Access Compliance Report

Public Rights-of-Way

Intersection ID: N/A	Main Street: SUMMERFIELD RIDGE LN	Cross Street: LITTLE SRREAM CT	Location: SW
ADA ID: 10626079866D	Ramp Type: PerpDiag	Initial Pass/Fail: Fail	Overall Compliance: No
		Severity Score: 50

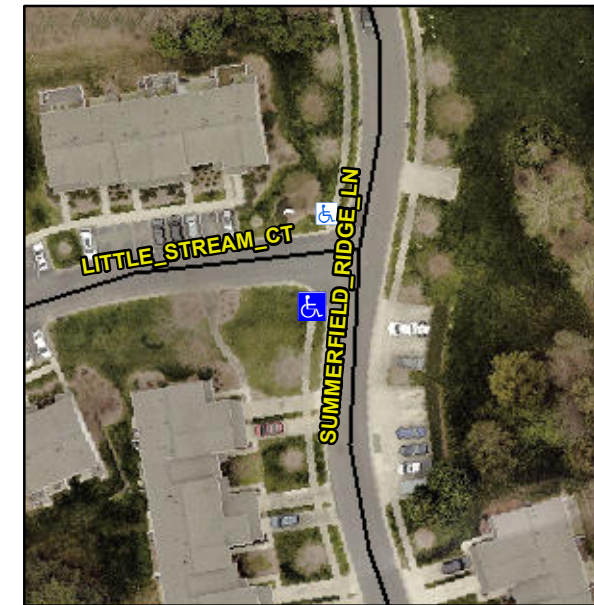
R304.2.2, R304.5.3

Compliance	Description	Data	Compliance	Description	Data
N/A	Ramp Length (in)	57.0	No	Ramp Slope (%)	14.4
Yes	Ramp Width (in)	57.0	No	Ramp XSlope (%)	8.0
N/A	Flare Type LT	N/A	N/A	Flare Type RT	N/A
N/A	Flare Slope LT (%)	N/A	N/A	Flare Slope RT (%)	N/A
N/A	Flare Traversable LT?	No	N/A	Flare Traversable RT?	No
N/A	Landing Length (in)	N/A	N/A	DWS Provided?	N/A
N/A	Landing Width (in)	N/A	N/A	DWS Contrast?	N/A
N/A	Landing Slope (%)	N/A	N/A	DWS Length (in)	N/A
N/A	Landing X Slope (%)	N/A	N/A	DWS Full Width?	N/A
N/A	Landing Curb? (Y/N)	N/A	N/A	DWS Offset (in)	N/A
N/A	Shared Landing?	N/A			
N/A	Gutter Ponding?	N/A	N/A	Gutter Slope (%)	N/A
N/A	Gutter Lip Ht (in)	N/A	N/A	Gutter X Slope (%)	N/A
N/A	Painted X Walk1?	No	N/A	Painted X Walk2?	No
	X Walk 1 Direction	To E		X Walk 2 Direction	To N
N/A	X Walk 1 Width (in)	N/A	N/A	X Walk 2 Width (in)	N/A
	X Walk 1 Slope (%)	2.5		X Walk 2 Slope (%)	1.5
	X Walk 1 X Slope (%)	1.8		X Walk 2 X Slope (%)	3.1

Remove & Replace Curb Ramp With Two New Directional Ramps or Equivalent.
